Hearing Examiner Staff Report and Recommendation

Project Name: Roth – Critical Area Buffer Reduction for Single Family Residence
Type of Application: Critical Area Variance (Type III)
Permit Number: 20-02620

13031 NW Taterbug Court, Bremerton
Commissioner District 3 (South)

6. Site Design

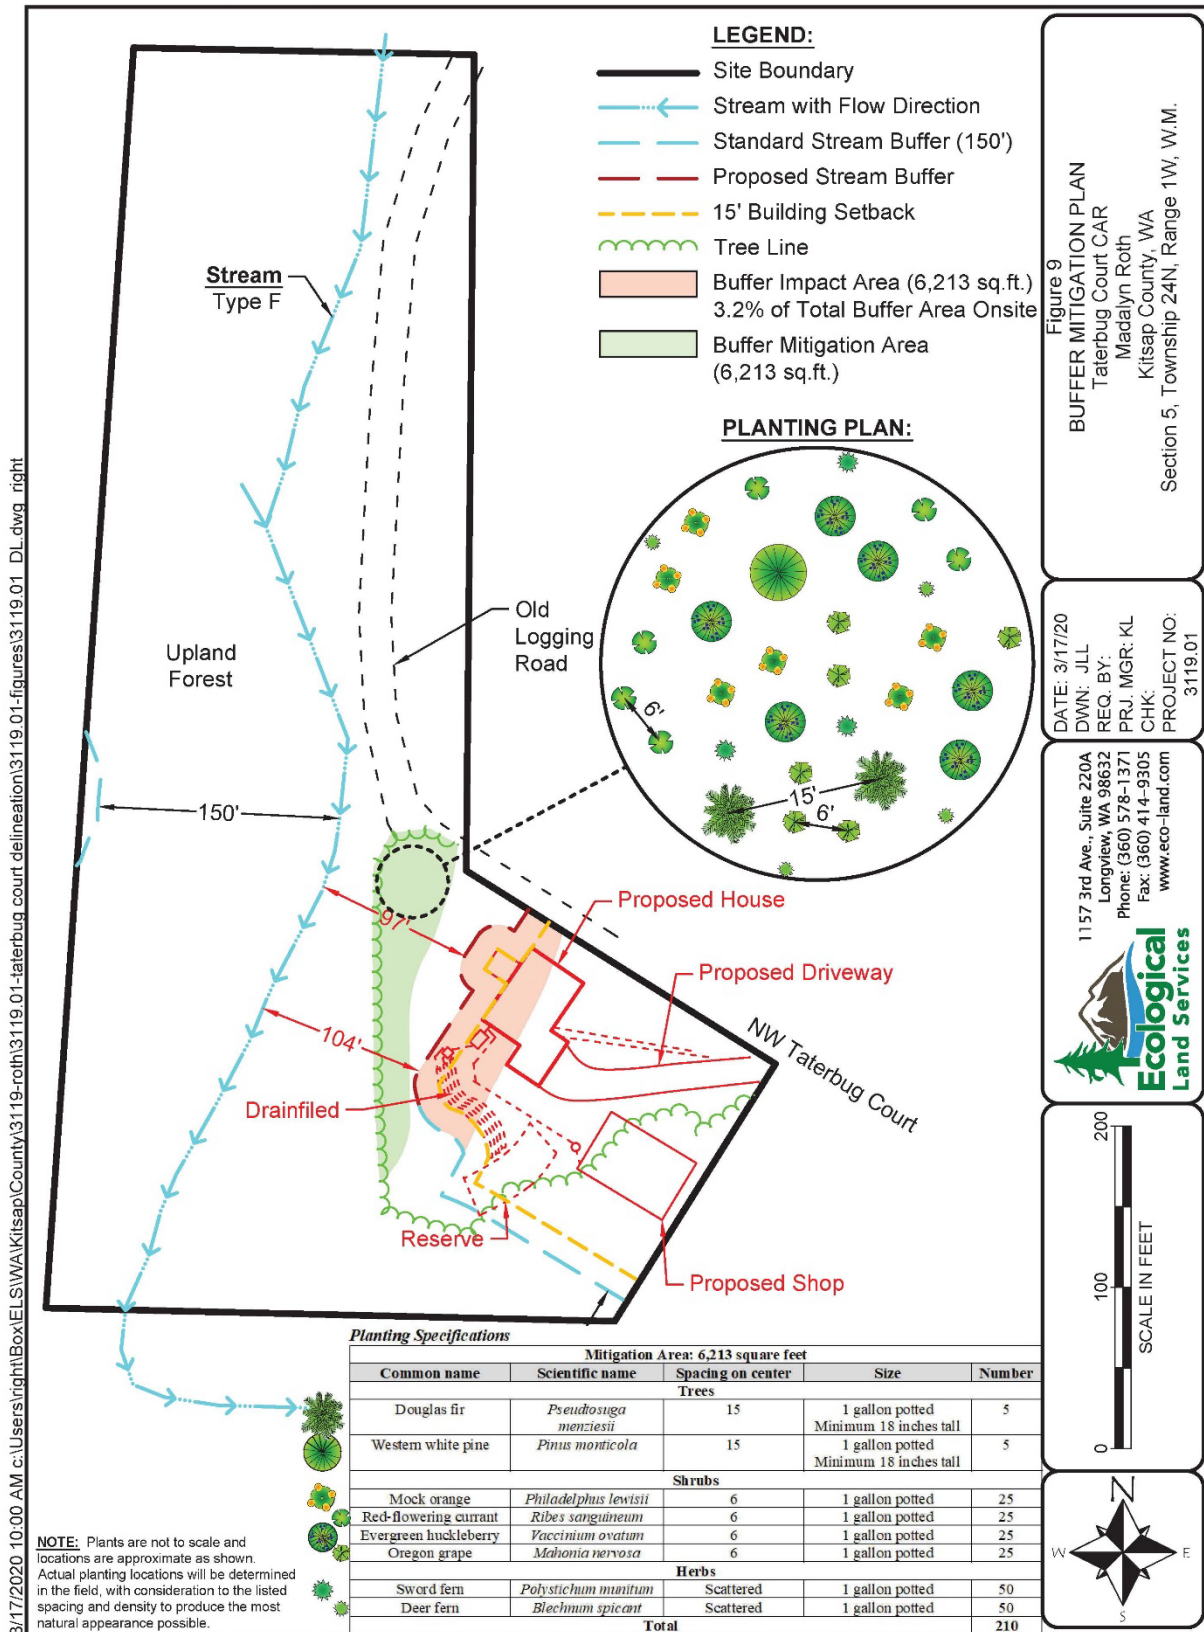
The image on the next page shows the proposed single-family home, driveway, septic drainfield and mitigation area. The proposed shop is no longer part of the proposal.

Staff Comment: The request is to reduce the 150-foot buffer to 97 feet to

accommodate the patio of the proposed home, and a reduction to 104 feet to accommodate the septic drainfield. The standard buffer will be retained elsewhere on the site. The 5.01-acre site will remain largely unimpacted by the proposed development. 6,213 square feet of standard buffer area will be impacted by the proposed single-family dwelling and associated septic system. The proposal includes 6,213 square feet of mitigation plantings to offset development within the standard buffer.

10. Unless otherwise allowed through this variance, a 150-foot native vegetation buffer must be maintained along the boundary of the unnamed stream as depicted on the approved plans. In addition, a building or impervious surface setback line of 15 feet is required from the edge of the buffer, unless otherwise approved by this variance.

11. The variance to the stream buffer shall be the minimum necessary to accommodate the proposed development and in no case may exceed 35% of the required buffer.
